**CITY PLAN COMMISSION****THURSDAY, April 23, 2026****FILE NUMBER:** PLAT-26-000100**SENIOR PLANNER:** Hema Sharma**LOCATION:** bounded by East Grand Avenue, Henderson Avenue, Beeman Avenue and Barry Avenue**DATE FILED:** March 27, 2026**ZONING:** IM**CITY COUNCIL DISTRICT:** 2**SIZE OF REQUEST:** 3.2231-acres**APPLICANT/OWNER:** City Warehouse, L.P.

**REQUEST:** An application to replat a 3.2231-acre tract of land containing all of Lots 1-3 in City Block A/1646, Lots 1-18 in City Block B/1646, Lots 1-13 in City Block C/1646, Lots 1-15 in City Block D/1646, Lots 1-5 in City Block E/1646, Lots 1-36 in City Block F/1646, Lots 1-26 in City Block G/1646, Lots 1-18 in City Block H/1646, Lots 1-21 in City Block K/1646, Lots 1-13 in City Block L/1646, Lots 1-31 in City Block M/1646, Lots 1-14 in City Block N/1646, Lots 1-18, Block 12/1636, Lots 1-13 in City Block 15/1643, Lots 1-7 in City Block 17/1645, Lot 43B in City Block 1450; portion of Lots 39A through 39D in City Block 1455 and to abandon right-of ways and alleys and to create one lot on property bounded by East Grand Avenue, Henderson Avenue, Beeman Avenue and Barry Avenue.

**PRELIMINARY PLAT**  
**CITY WAREHOUSE ADDITION**  
**

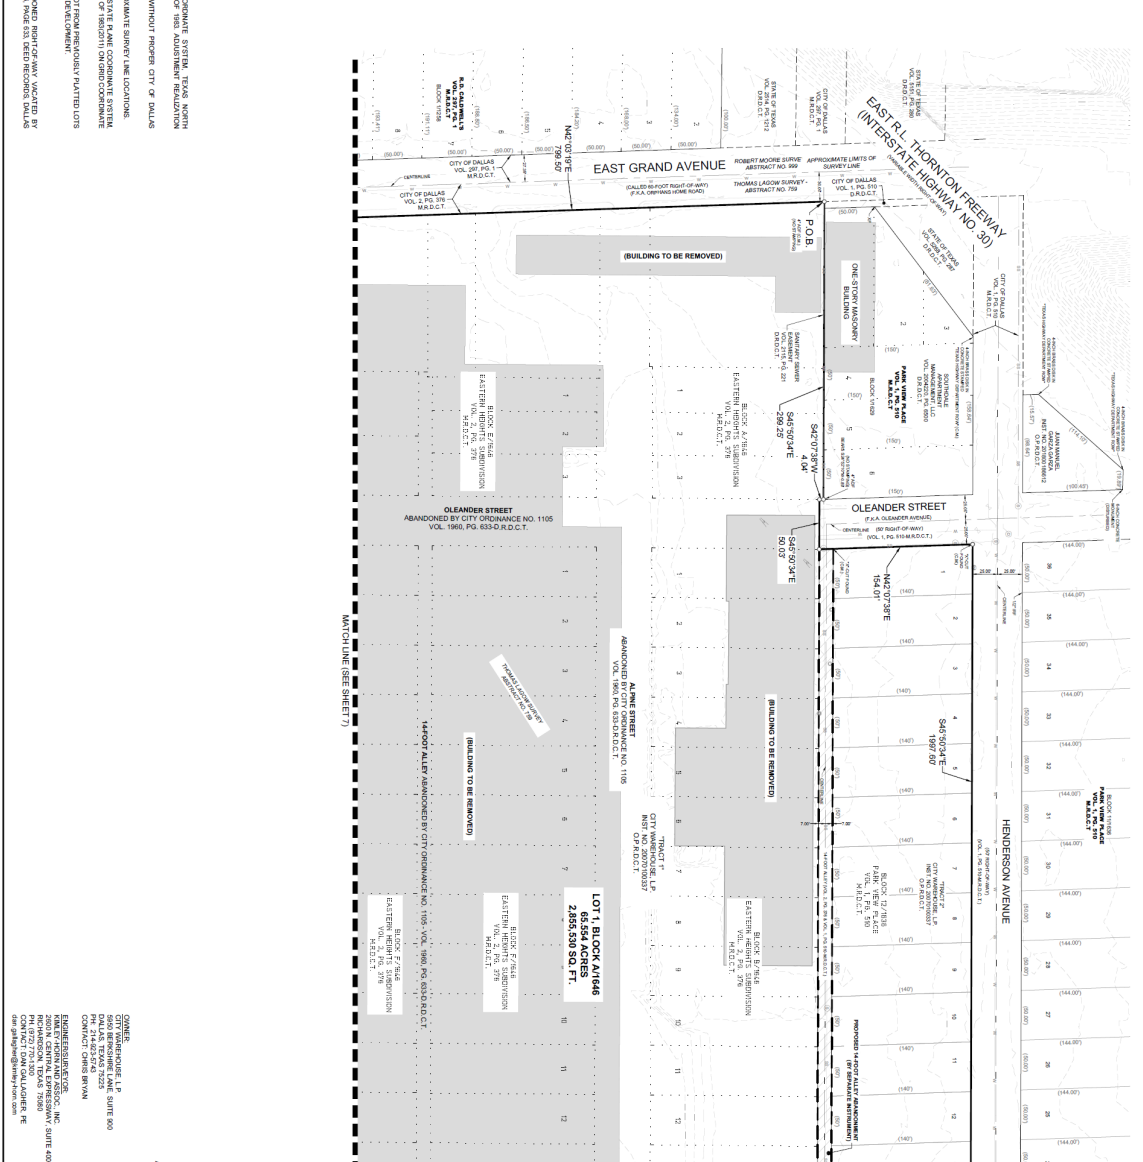
15. On the final plat, dedicate 30 feet of right-of-way (via fee simple) from the established center line of East Grand Avenue. *Section 51A 8.602(c)*
16. On the final plat, dedicate 50 feet of right-of-way (via fee simple) from the established center line of Barry Avenue. *Section 51A 8.602(c)*

17. On the final plat, dedicate 45 feet of right-of-way (via fee simple) from the established center line of Haskell Avenue. *Section 51A 8.602(c)*
18. On the final plat, dedicate 28 feet of right-of-way (via fee simple or street easement) from the established centerline of Henderson Avenue. *Sections 51A-8.602(c), 51A-8.604(c) and 51A-8.611(c).*

19. On the final plat, dedicate 28 feet of right-of-way (via fee simple or street easement) from the established centerline of Beeman Avenue. *Sections 51A-8.602(c), 51A-8.604(c) and 51A-8.611(c).*

20. On the final plat, dedicate 28 feet of right-of-way (via fee simple or street easement) from the established centerline of Oleander Avenue. *Sections 51A-8.602(c), 51A-8.604(c) and 51A-8.611(c).*

21. On the final plat, dedicate alley ROW of at least 7.5 feet from centerline (1 foot) per 51A 8.507(b)(1).
22. On the final plat, dedicate a minimum 5-foot by 5-foot corner clip (via fee simple or street easement) at the intersection of Oleander Street & Henderson Avenue. *Section 51A 8.602(d)(1)*

24. On the final plat, dedicate a 15-foot by 15-foot Alley Sight Easement at the intersection of Beeman Avenue & the alley. *Section 51A-8.602(e)*
25. Must coordinate with Transportation Department for any traffic signal requirements that are deemed necessary for improving pedestrian accessibility and safety related to site development (Contact Srinivasa Veeramallu with Traffic Signals). *51A-8.606, 51A-8.608*

42. Prior to the final plat, please see Real Estate for Proposed 14-foot alley abandonment and 14-foot alley dedication.
43. On the final plat, change "East R.L. Thronton Freeway (Interstate Highway No. 30)" to "R.L. Thornton Freeway/Interstate Highway No. 30 (AKA U.S. Highway No. 67)" Section 51A-8.403(a)(1)(A)(xii).

44. On the final plat, change "Sidney Street" to "Sidney Avenue". Section 51A-8.403(a)(1)(A)(xii).
45. On the final plat, change "Hamilton Street" to "Hamilton Avenue (AKA Hamilton Street)". Section 51A-8.403(a)(1)(A)(xii).

46. On the final plat, change "S. St Mary Avenue" to "St. Mary Avenue" Section 51A-8.403(a)(1)(A)(xii).
47. On the final plat, identify the property as Lot 1 in City Block A/1646.
